jjohnson@blackfoot.com; MBlakely@hellgate.k12.mt.us; rwatson@mcps.k12.mt.us; bmcwilliams@mcps.k12.mt.us;
Dave DeGrandpre <DeGrandpreD@ci.missoula.mt.us>
Cc: Tara Porcari <PorcariT@ci.missoula.mt.us>
Subject: [EXTERNAL]Meadow View Homes 1st Agency Sufficiency Review

Engineering Sufficiency Review – Meadow View Homes Subdivision

Meadow View Homes Subdivision 1st Sufficiency Review

DESIGN SLOPE MAP

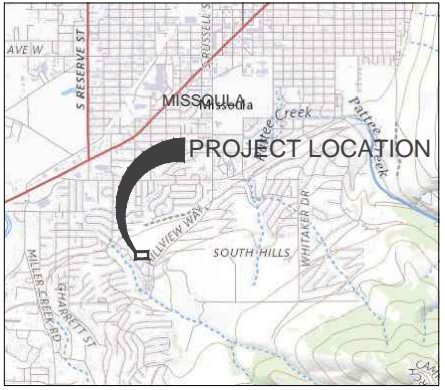
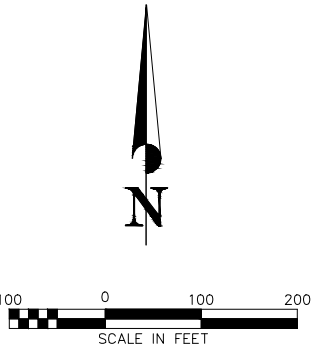
Include trail connection from Tonka trail to City land near NE corner of CA4

These portions of CA3 and CA4 must contain trails and trail connections to the Tonka Trail to be counted towards parkland dedication requirements.

Area with access easement does not meet parkland dedication requirements. relocate Tonka Trail & trailhead to be outside of access easement for future street

Does not meet parkland dedication requirements

Does not meet Parkland dedication requirements

Does not meet parkland dedication requirements

Slopes exceed parkland dedication requirements

Does not meet parkland dedication requirements
